Dominion Nuclear Connecticut, Inc.  
Millstone Power Station  
Rope Ferry Road  
Waterford, CT 06385

Docket No. 50-423  
B18314

Millstone Nuclear Power Station, Unit No. 3  
Technical Specifications Change Request 3-11-00  
Reactor Coolant System Heatup and Cooldown Curves

FIGURE 3.4-4a

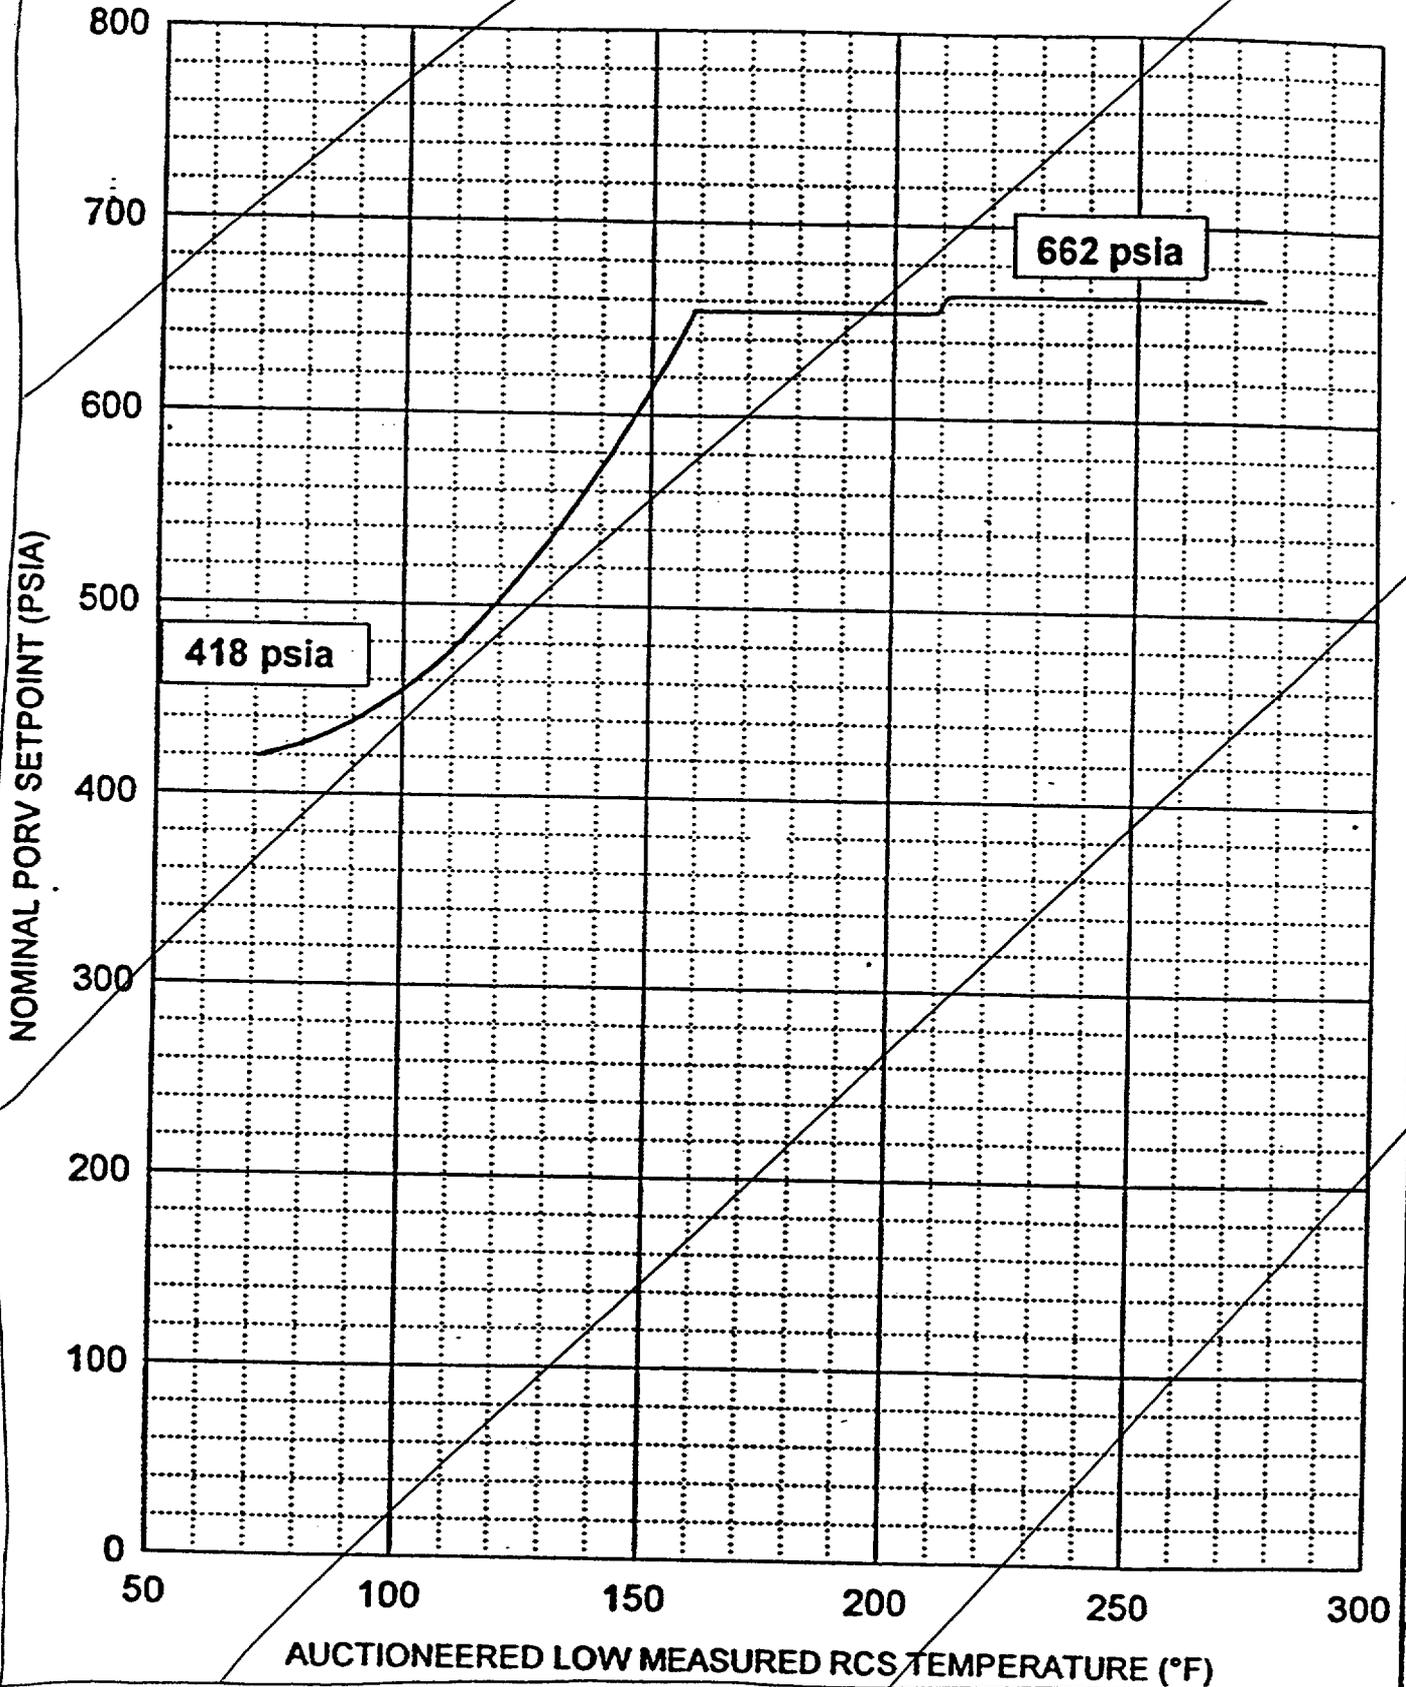
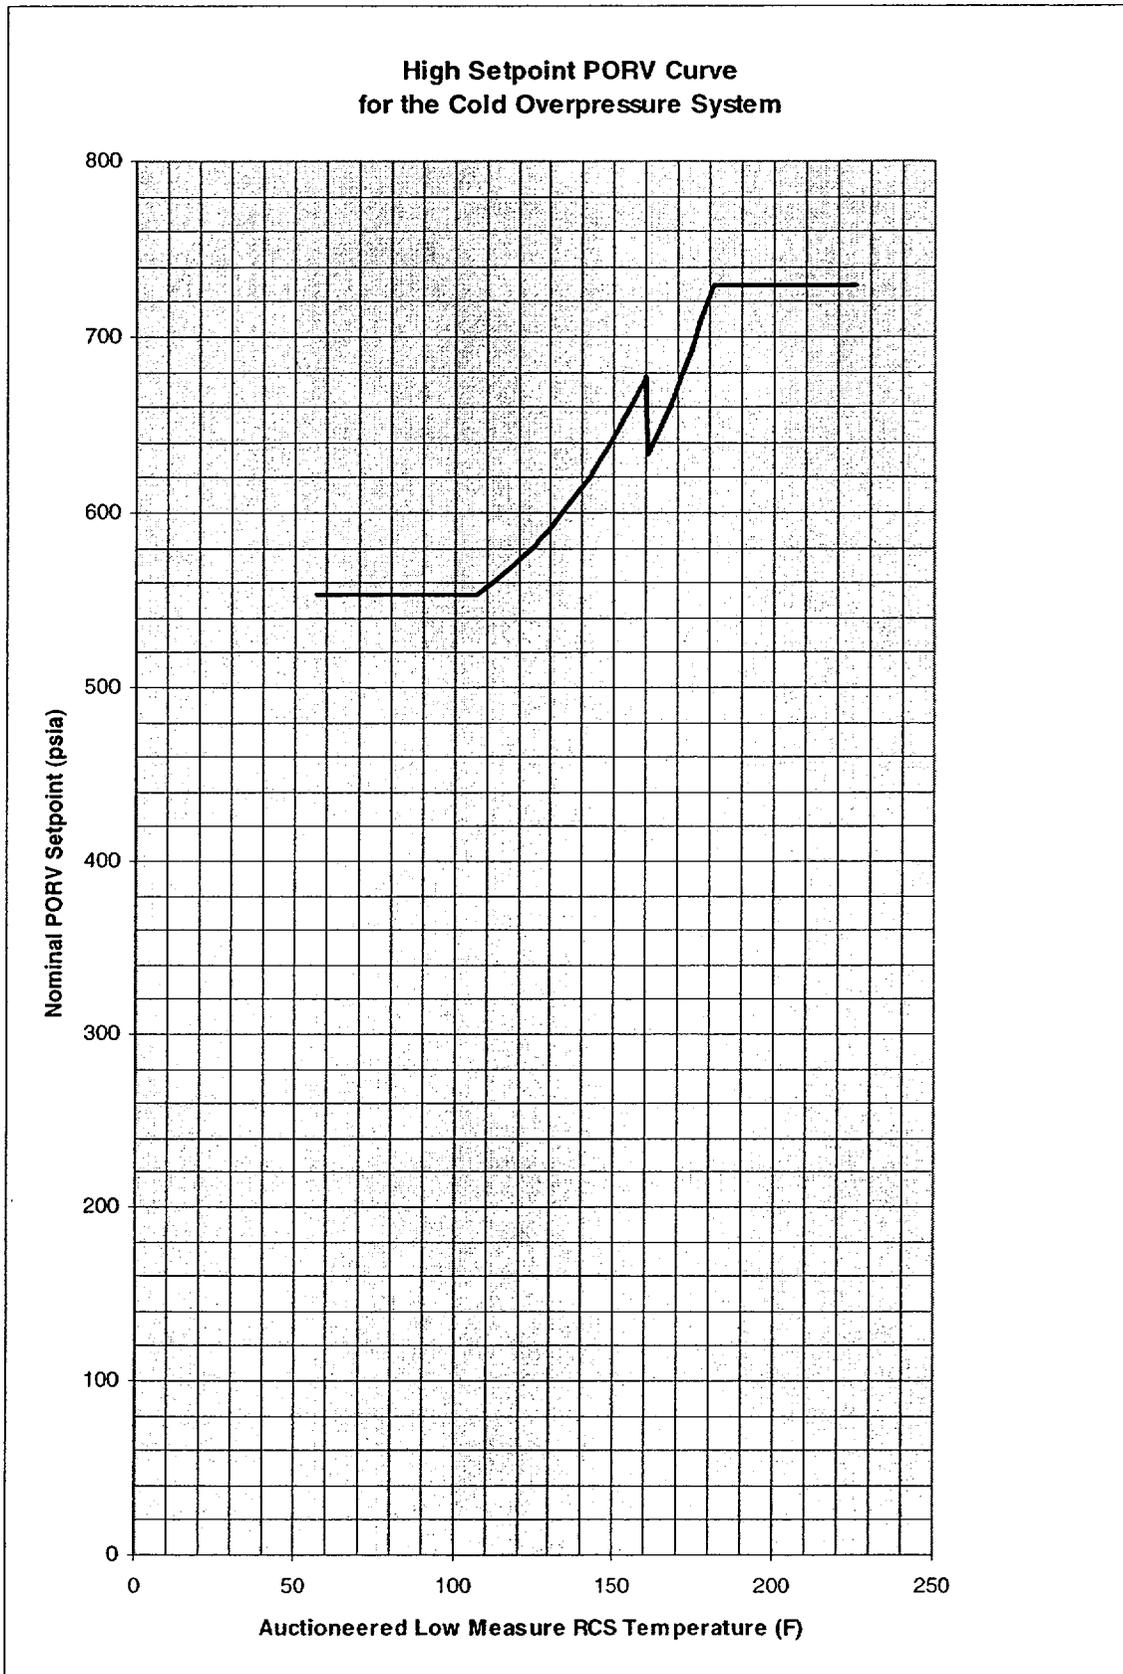
9. Figures 3.4-4a and 3.4-4b will be replaced by new curves based on the revised analysis.

### HIGH SETPOINT PORV CURVE FOR THE COLD OVERPRESSURE PROTECTION SYSTEM
